CITY OF ALBUQUERQUE

RE: KINESIO Headquarters
4001 Masthead St. NE
Requested for 30-day Temporary C. O. - Accepted
Engineers Stamp Date 2/5/16 (D17D103)

GRADING AND DRAINAGE PLAN

date 11-30-15 sheet C101

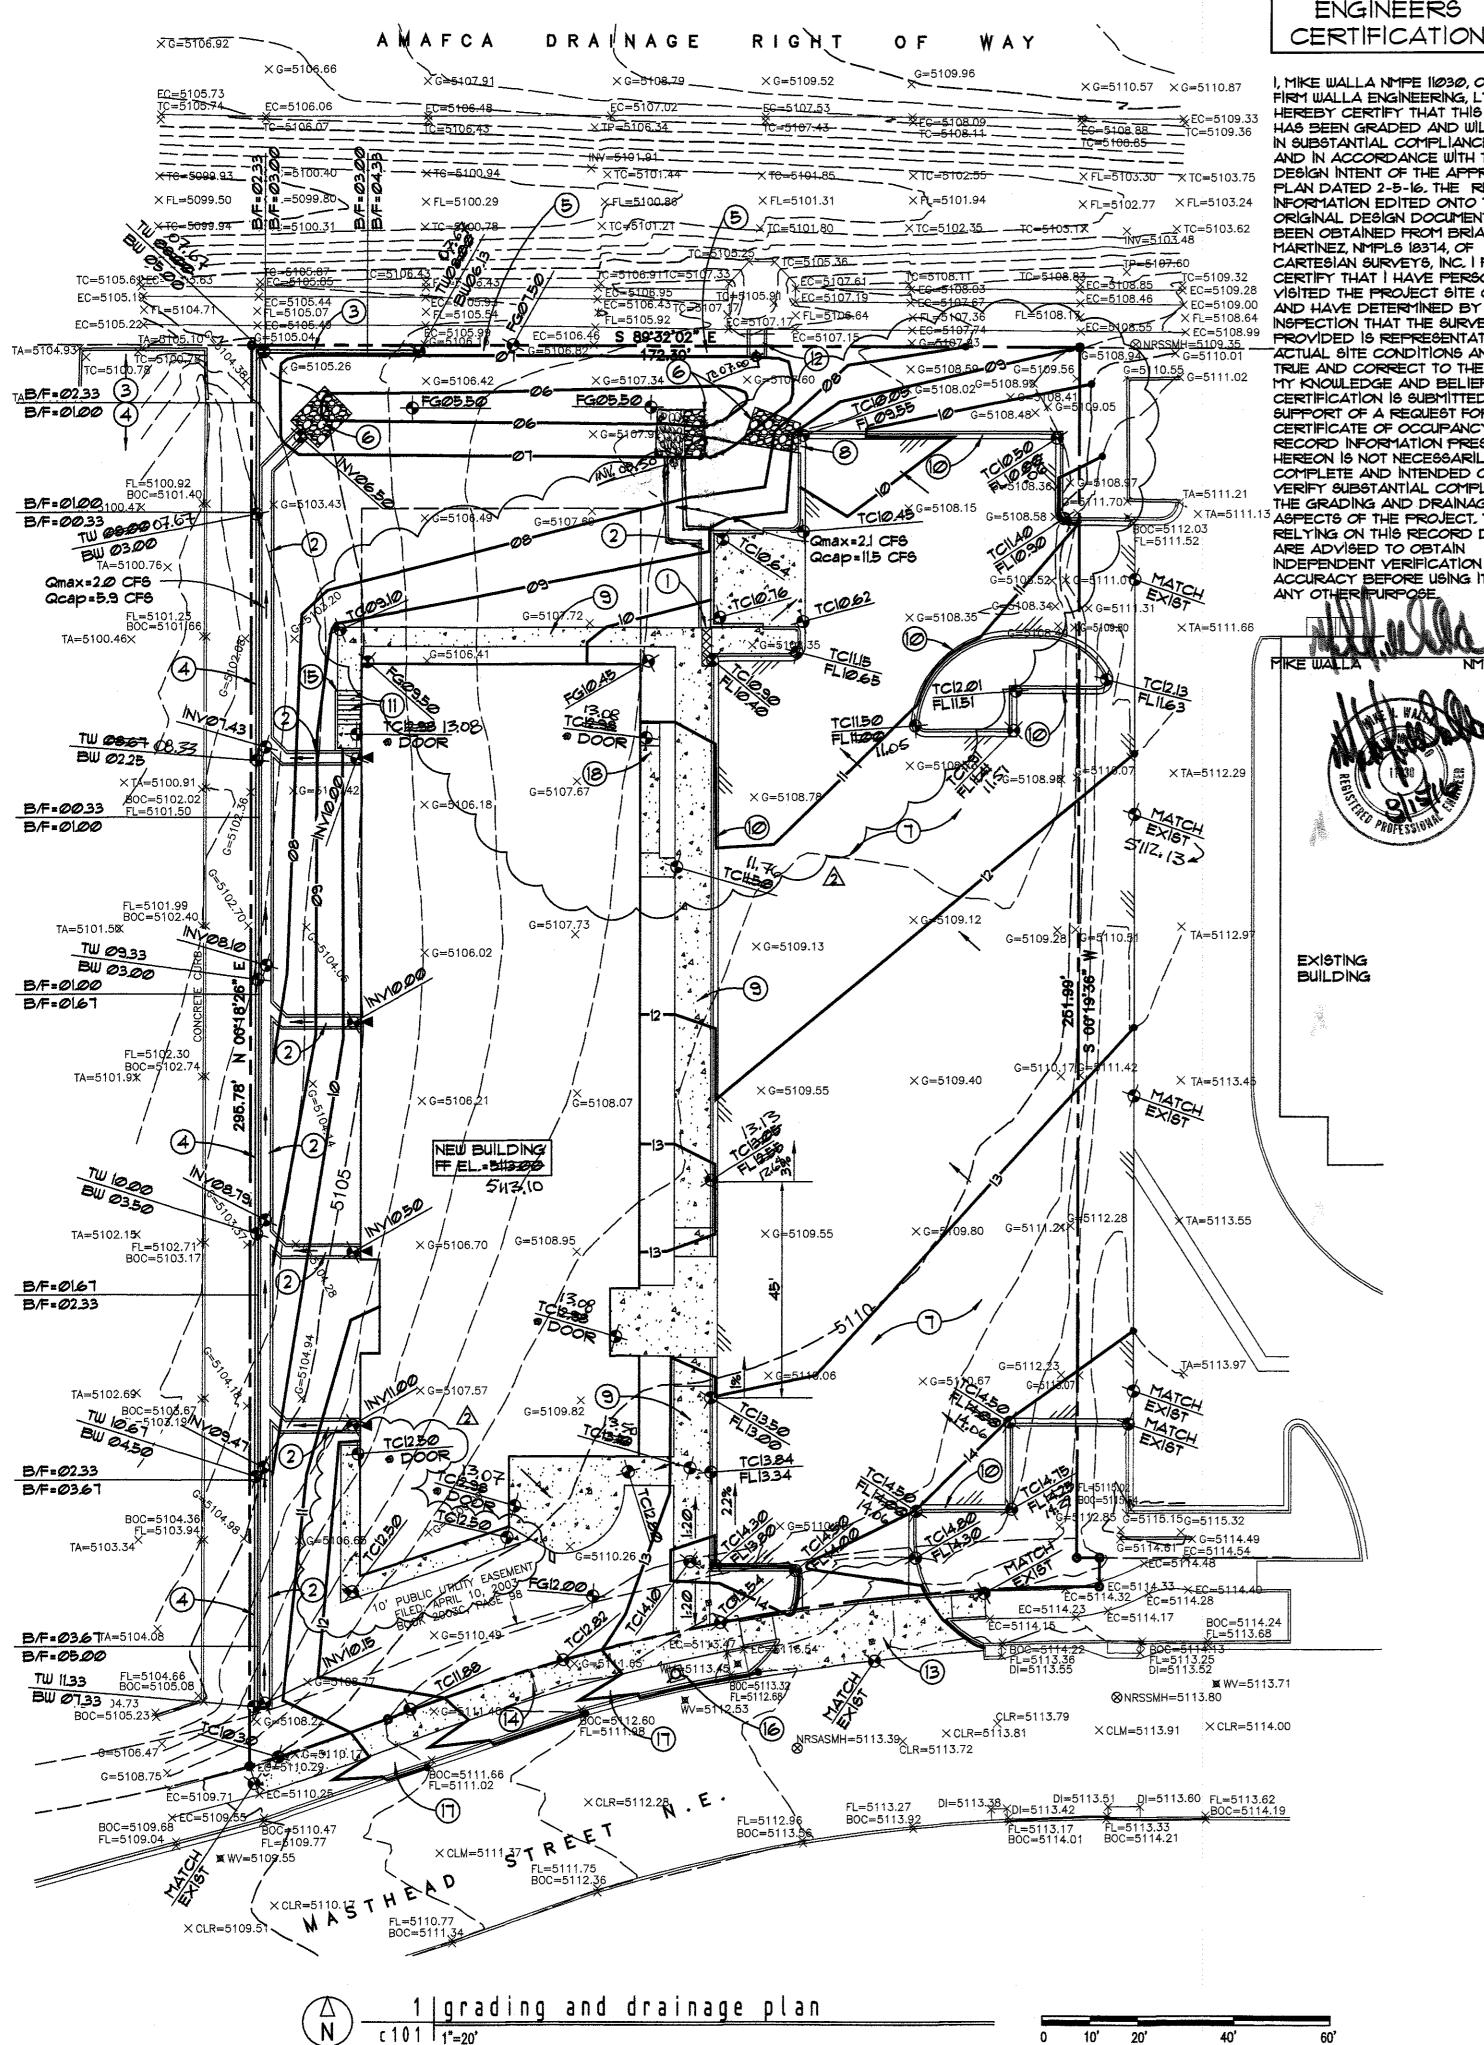
• The swale that fronts the property needs to be put in place.

• The transition between this property and the adjacent property to the west should be revised. The swaddle should be moved to the adjacent property. In its place fractured rock should be placed so any spillage from the 2' concrete rundown will overflow on top of the fractured rock prior to draining on to the swaddle.
